Access Compliance Report Public Rights-of-Way (Curb Ramps)

Main Street: CREW_DR Cross Street: PACIFIC_AVE Location: NE

ADA ID: RPRK210922130039 Ramp Type: Type 1 - Perpendicular Diagonal Initial Pass/Fail: Fail Overall Compliance: No Severity Score: 30

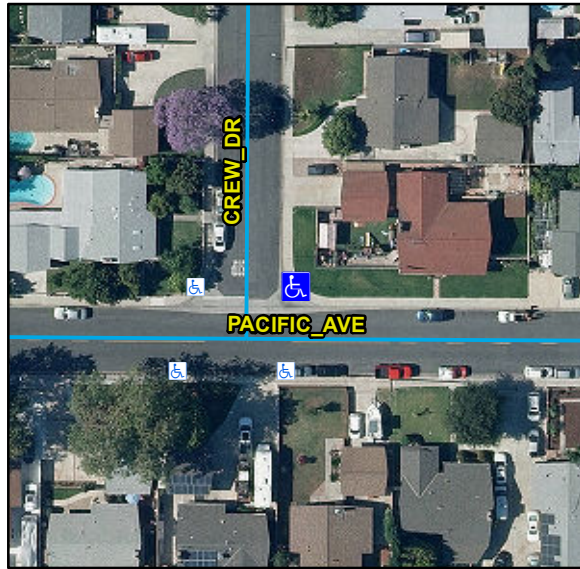
Compliance	Description	Data	Compliance	Description	Data
N/A	Ramp Length (in)	50	N/A	Flare Type LT	
Yes	Ramp Width (in)	48			N/A
No	Ramp Run Slope (%)	12.2	N/A	Flare Slope LT (%)	N/A
Yes	Ramp Cross Slope (%)	0.5	N/A	Flare Traversable LT	N/A
N/A	Landing Present	N/A	N/A	Flare Type RT	
N/A	Landing Length (in)	N/A			N/A
N/A	Landing Width (in)	N/A	N/A	Flare Slope RT (%)	N/A
N/A	Landing Run Slope (%)	N/A	N/A	Flare Traversable RT	N/A
N/A	Landing Cross Slope (%)	N/A	N/A	DWS Provided	N/A
N/A	Landing Movement Obstructed?	N/A	N/A	DWS Contrast	N/A
	Landing Movement Type	N/A	N/A	DWS Length (in)	N/A
N/A	Landing Shared	N/A	N/A	DWS Full Width	N/A
N/A	Clear Space	Yes	N/A	DWS Offset Left (in)	N/A
N/A	Clear Space To Crosswalk (in)	N/A	N/A	DWS Offset Right (in)	N/A
N/A	Marked Crosswalk 1	No	N/A	Marked Crosswalk 2	No
	Crossing 1 Direction	W		Crossing 2 Direction	S
	Marked Crosswalk 1 Width (in)	N/A		Marked Crosswalk 2 Width (in)	N/A

Remove & Replace Curb Ramp With Two New Directional Ramps or Equivalent.
